**Town of Kittery
Planning Board Meeting
March 28, 2024**

ITEM 1—181 State Road—Marijuana Business Site Plan — Final Review

Action: Approve plan or continue review. Mike Sudak, on behalf of owner/applicant IDC5 LLC, is proposing to replace an existing restaurant and single-family dwelling with a 2,000 square foot marijuana retail store and associated parking on the properties of 181-185 State Road, Tax Map 22, Lots 4-1 and 4-2, a parcel split by the Business Local and Old Post Road Commercial (C-3) Zone.

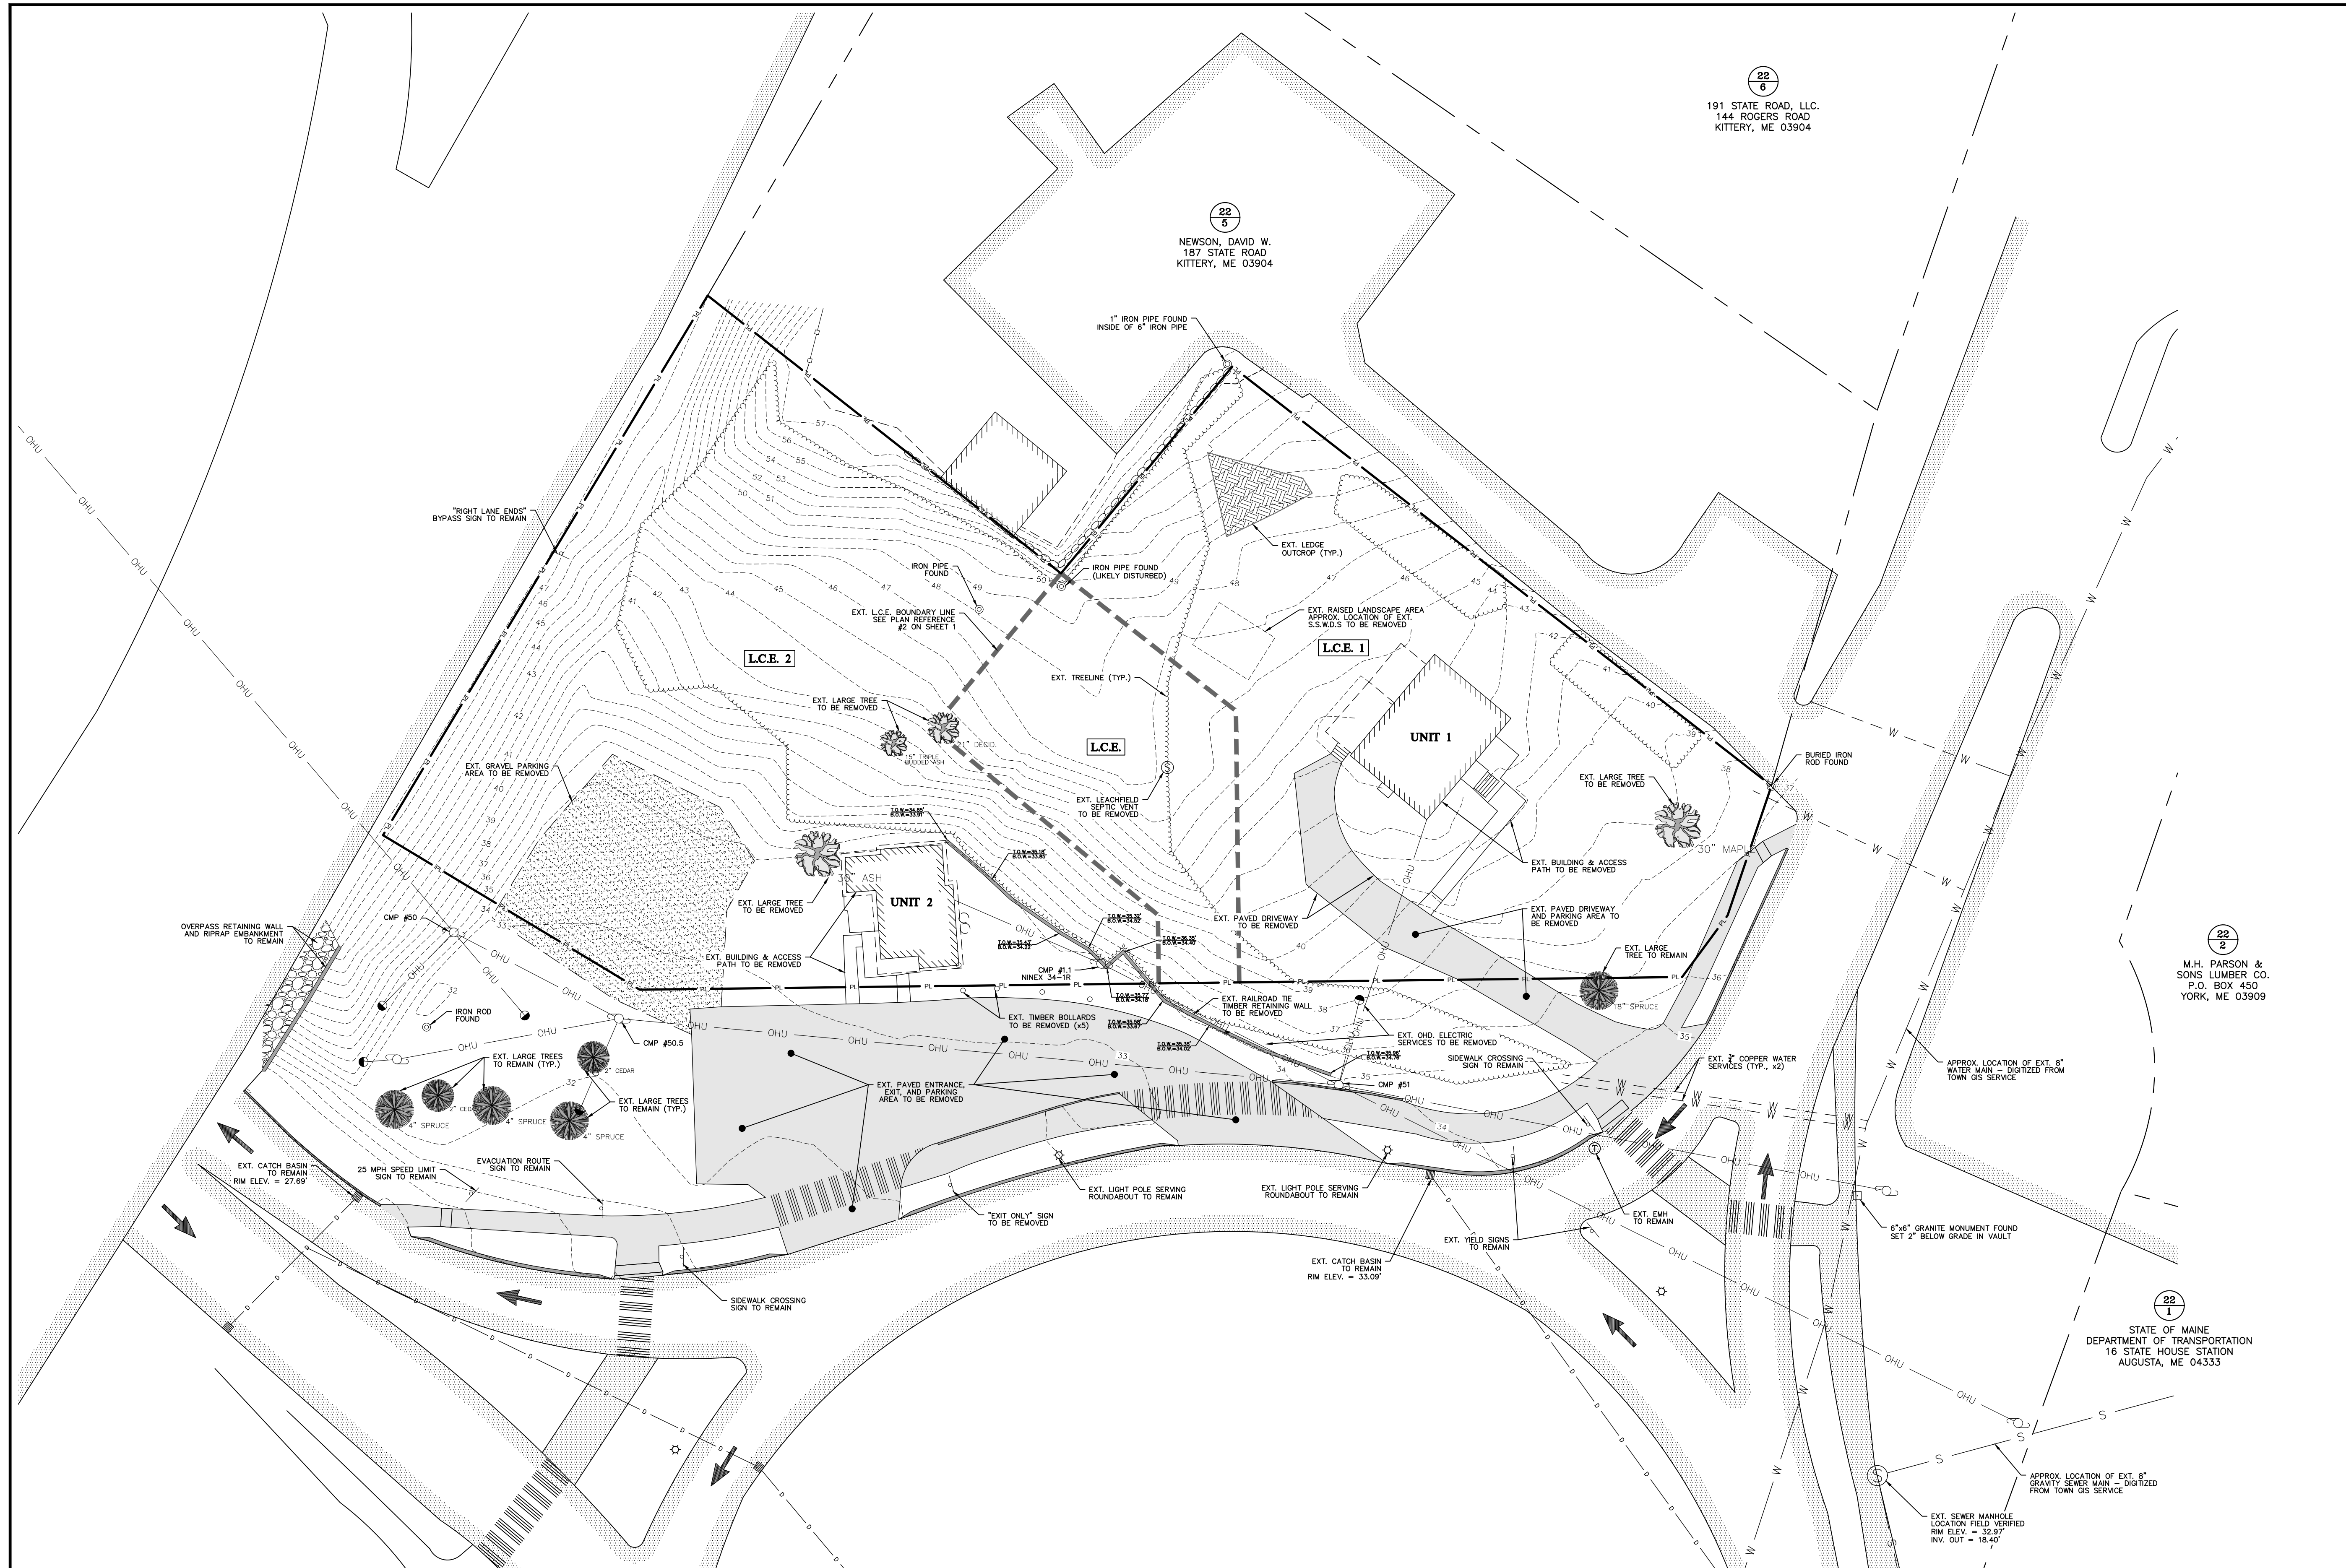
6. Following a request from the planning board, note #20 of the site plan addresses visual screening during construction. A 6-foot temporary fence will be placed during construction and remain until the evergreen hedges are established to provide sufficient visual screening of the property.

- Sheet #1 (Overall Site Plan) has been revised to include sight distance measurements at both the proposed entrance and exit. These measurements have also been provided in the Traffic Impact Study prepared by Vanasse & Associates, Inc.

- General Note #20 on Sheet #1 has been added to address the satisfaction of the visual screening requirements of §16.4.21.E.(3).(a). during construction. In response to discussion during the January 11th Planning Board meeting, a 6'-high temporary fence shall be erected during construction and shall remain until the abutting evergreen hedge is established to provide permanent visual screening.

**GRADING & UTILITIES PLAN
INDICO CANNABIS RETAIL
181 & 185 STATE ROAD, KITTERY MAINE**

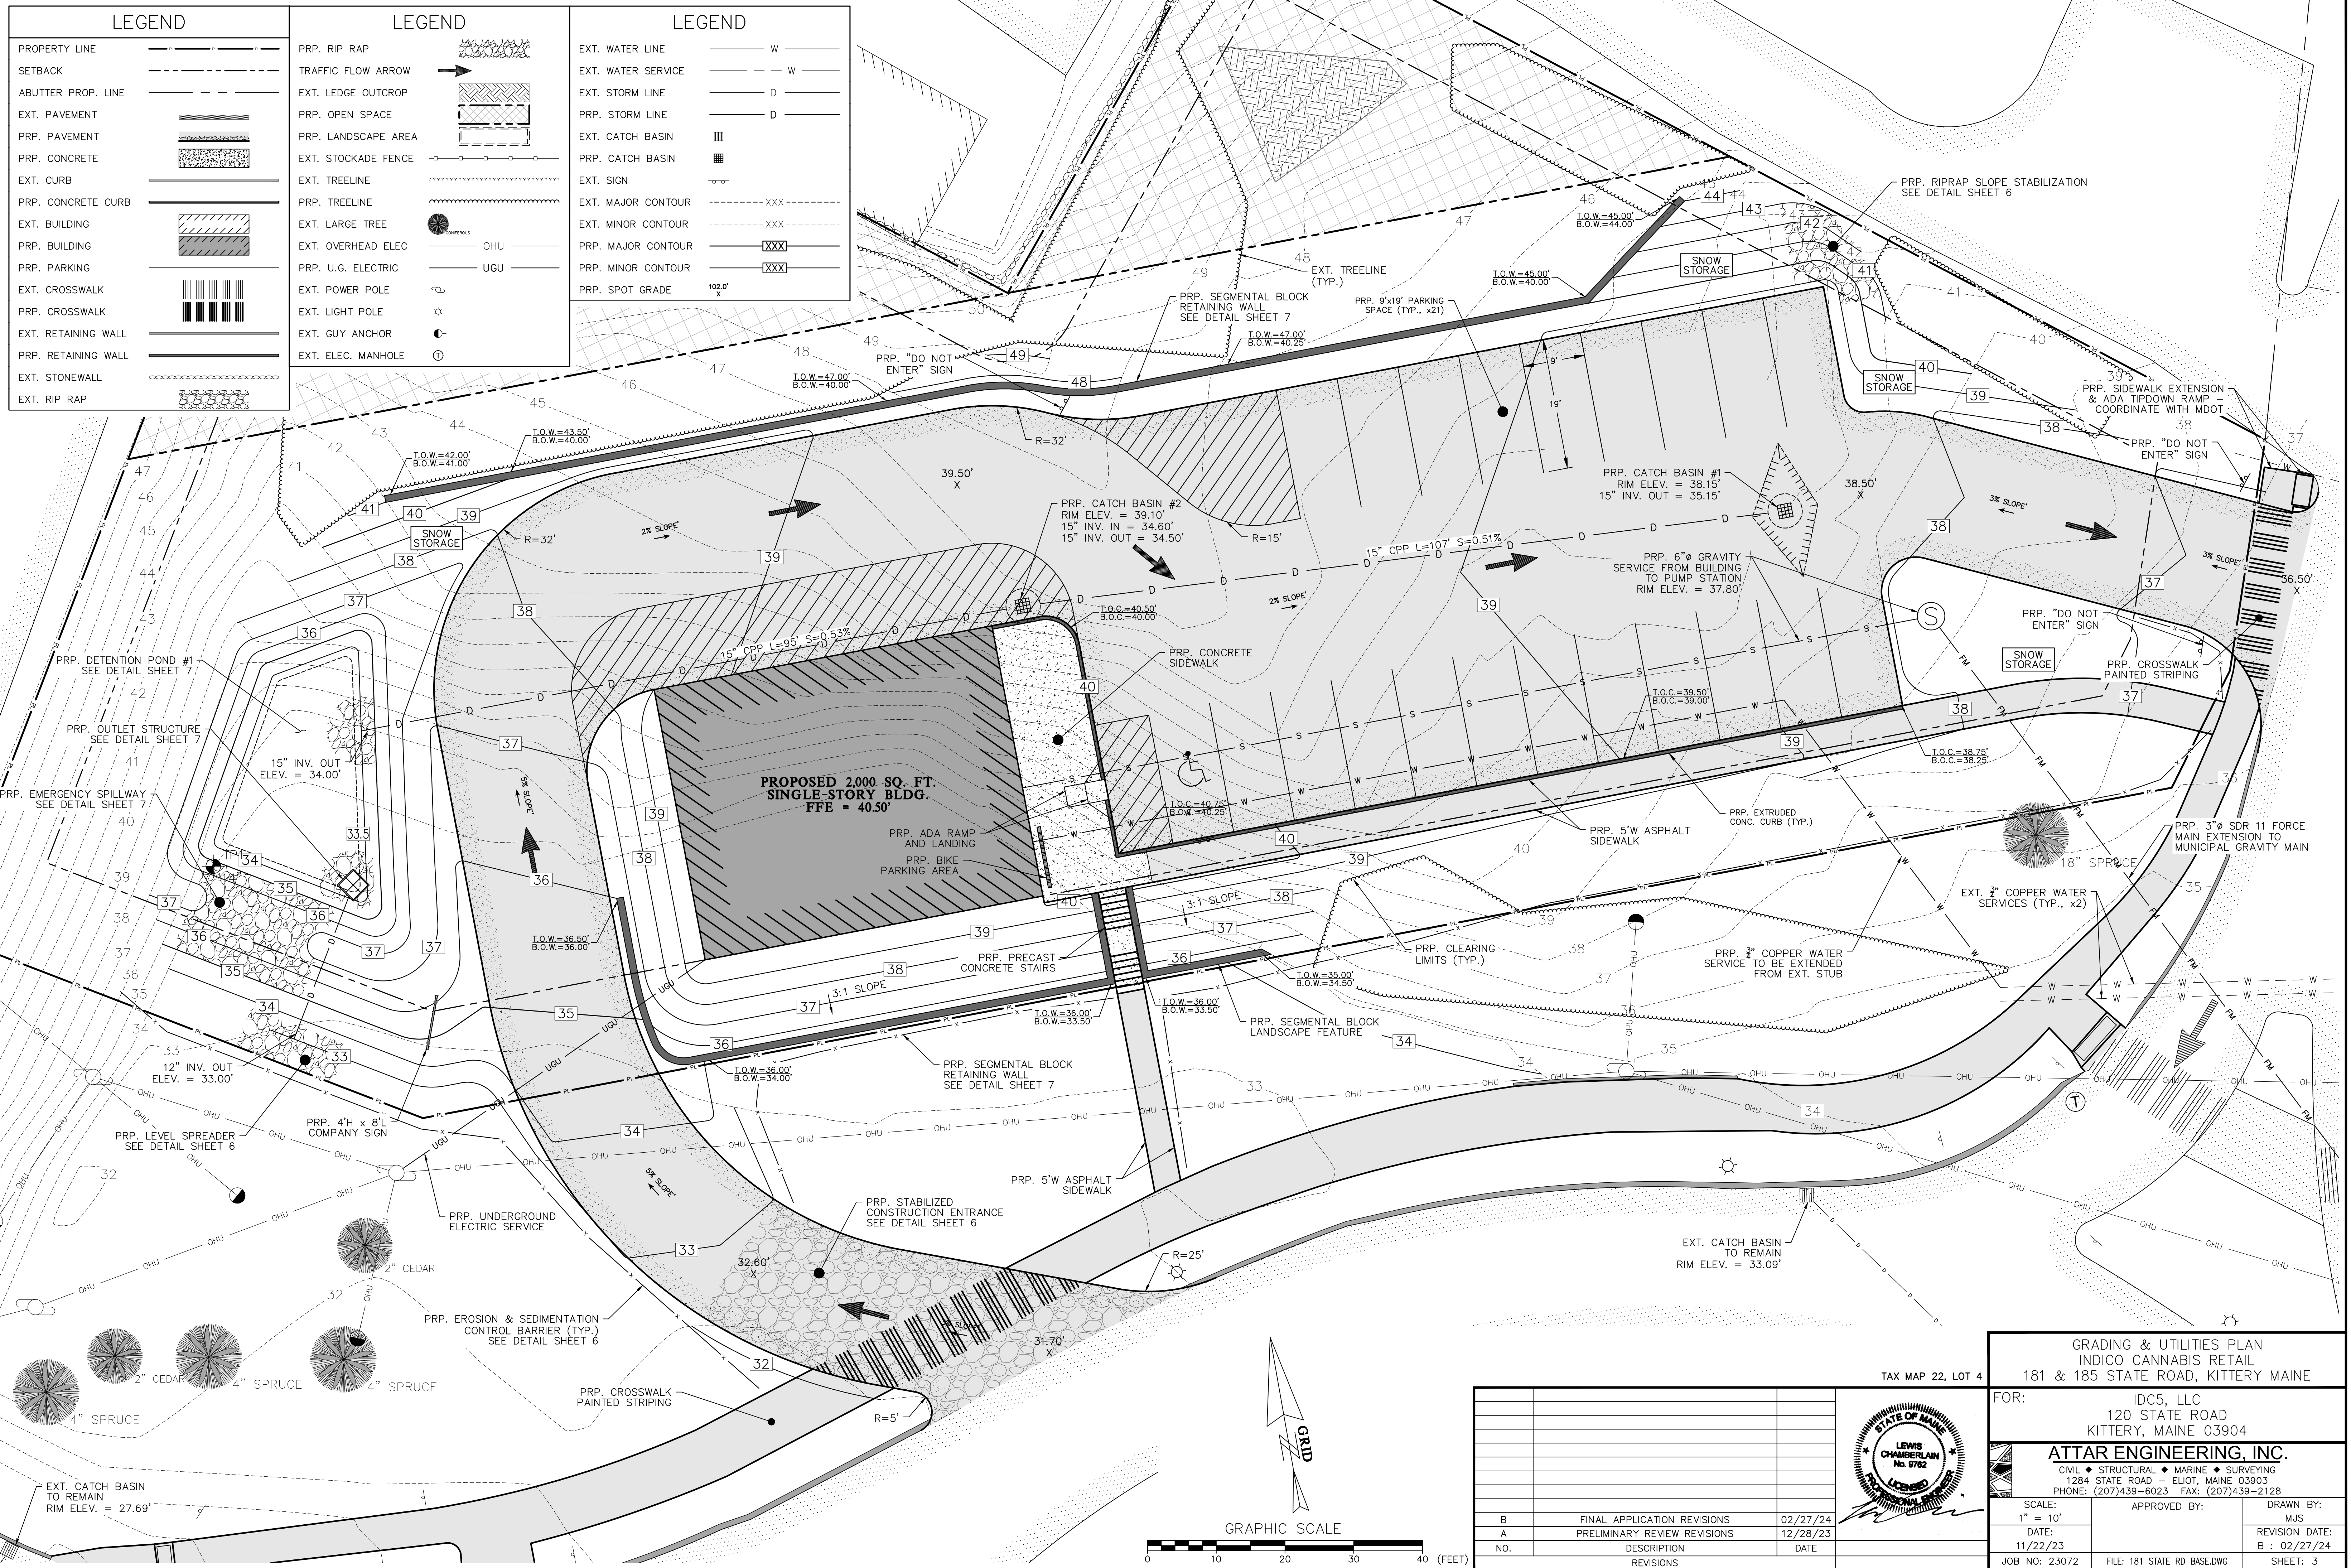
- Sheet #3 has been revised to include signage for the proposed ADA parking space and accompanying striped loading bay. Signage has also been added at the proposed exit, flanking either side of the travelway and facing east towards the existing spur road. These signs shall read "Do Not Enter" and shall discourage the use of the proposed exit as an entrance into the development.

- Sheet #3 (Grading & Utilities Plan) has been revised to include “Do Not Enter” signs positioned at the property line and flanking the proposed exit to the development. These signs should discourage vehicles from utilizing the proposed exit as an entrance to the nearby parking area.

LANDSCAPING PLAN
INDICO CANNABIS RETAIL
181 & 185 STATE ROAD, KITTERY MAINE

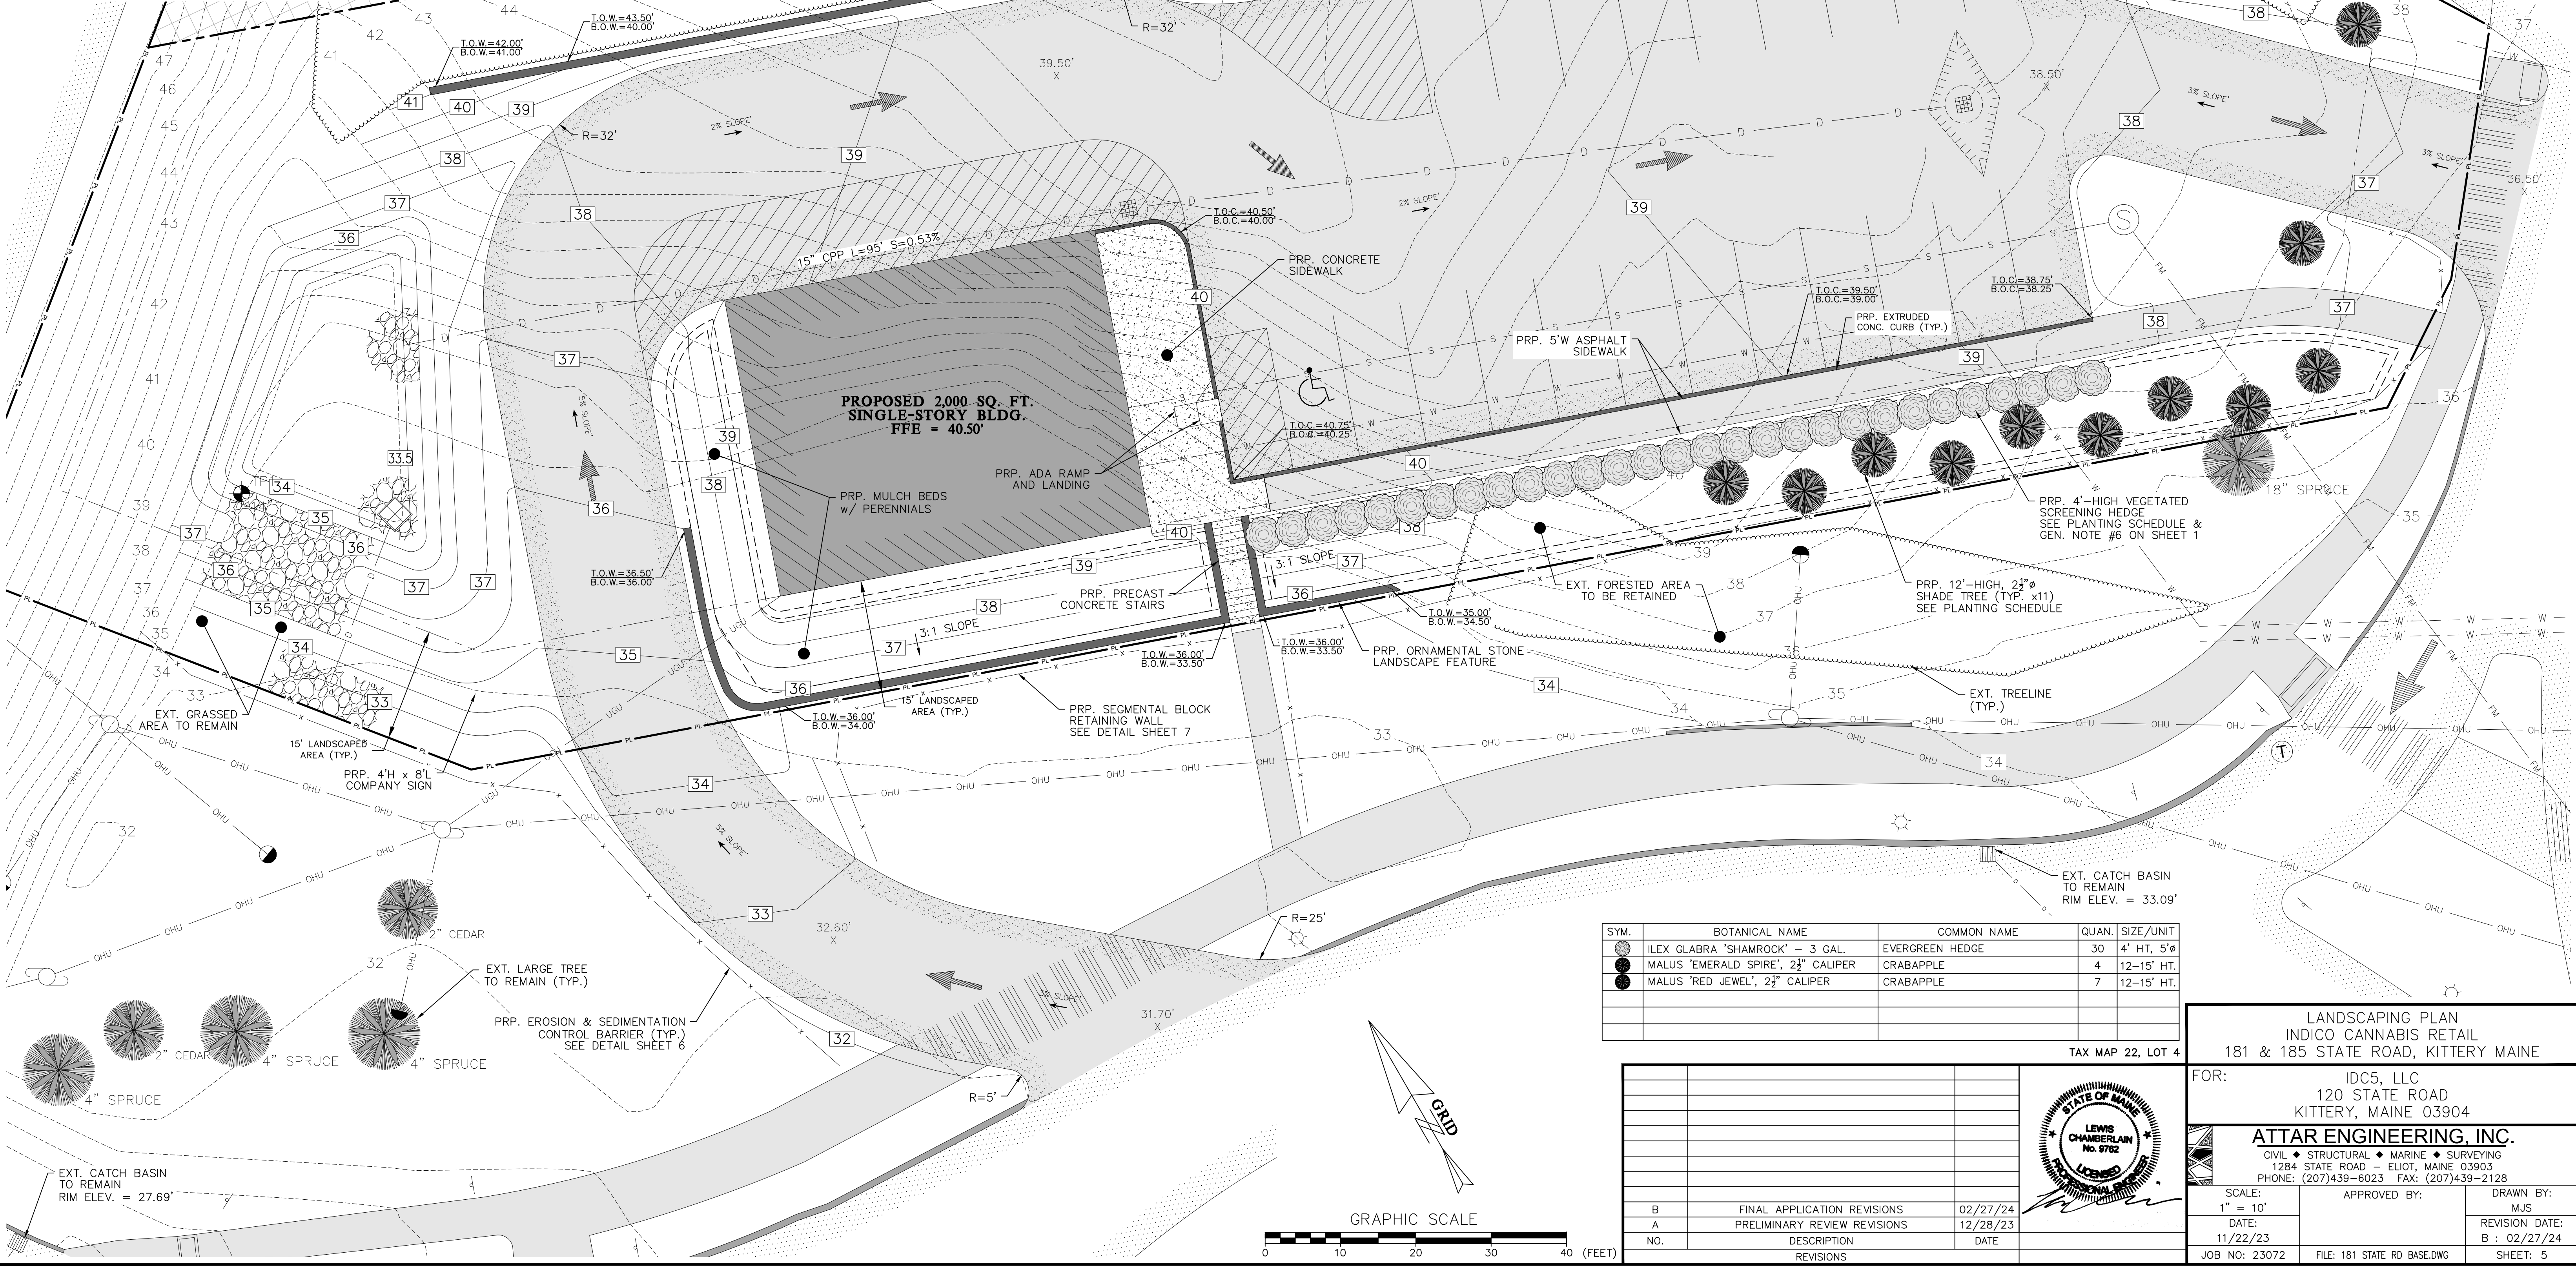
5. Following feedback from the planning board, the landscaping plan has been updated to provide limited height plantings within the front setback which do not impede the sight lines of the building from vehicles in the Kittery Traffic Circle.

- Sheet #5 (Landscaping Plan) has been revised to provide a wider variety of tree species proposed within the frontyard vegetated buffer for streetside tree planting requirements. Sample pictures are attached of the chosen tree and shrub species for this development.
